Addendum 35: Regulation No. 36

Revision 2 - Amendment 4

Supplement 10 to the 03 series of amendments - Date of entry into force: 13 November 2004

UNIFORM PROVISIONS CONCERNING THE APPROVAL OF LARGE PASSENGER VEHICLES WITH REGARD TO THEIR GENERAL CONSTRUCTION

"Figure 6b

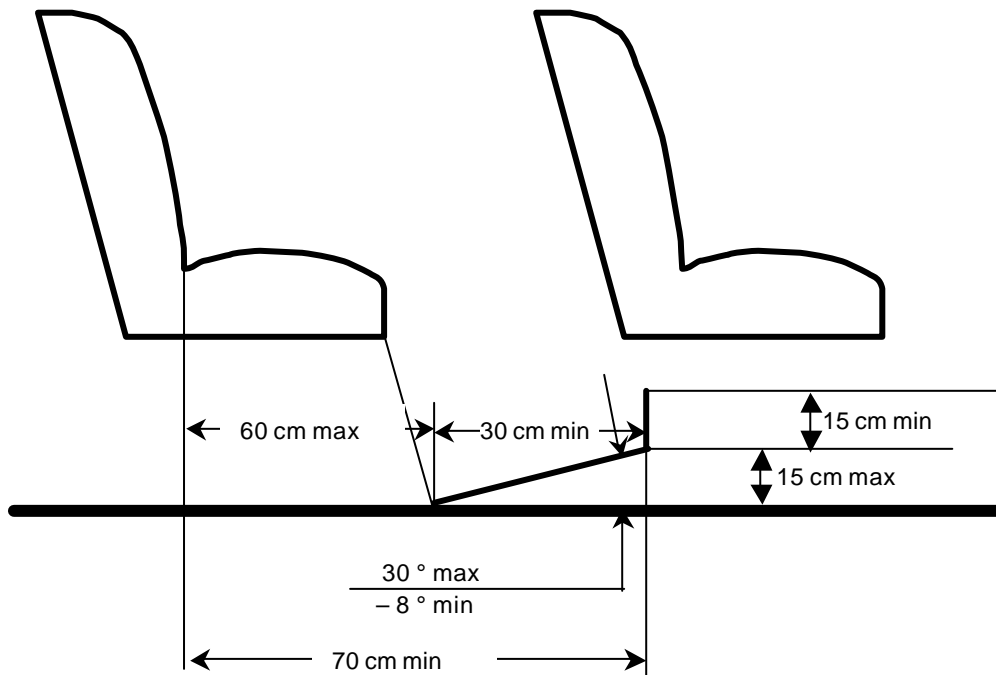
Insert a new figure 6b, to read:

SPACE FOR SEATED PASSENGERS BEHIND A SEAT AND/ OR A SEAT FACING THE GANGWAY
(see paragraph 5.7.8.5.2.)

Insert a new paragraph 5.7.8.5.2., to read:

"5.7.8.5.2. For a seat behind a seat and/or a seat facing the gangway, a minimum clear foot space of at least 300 mm depth and a width according to paragraph 5.7.8.1.1., shall be provided as shown in annex 3, figure 6b. The local presence in this space of seat legs and of intrusions as provided by paragraph 5.7.8.6.2.3. shall be permitted provided that adequate space remains for the passengers' feet. This foot space may partly be situated in and/or above the gangway but shall not create any obstruction when measuring the minimum gangway-width in accordance with paragraph 5.7.5."
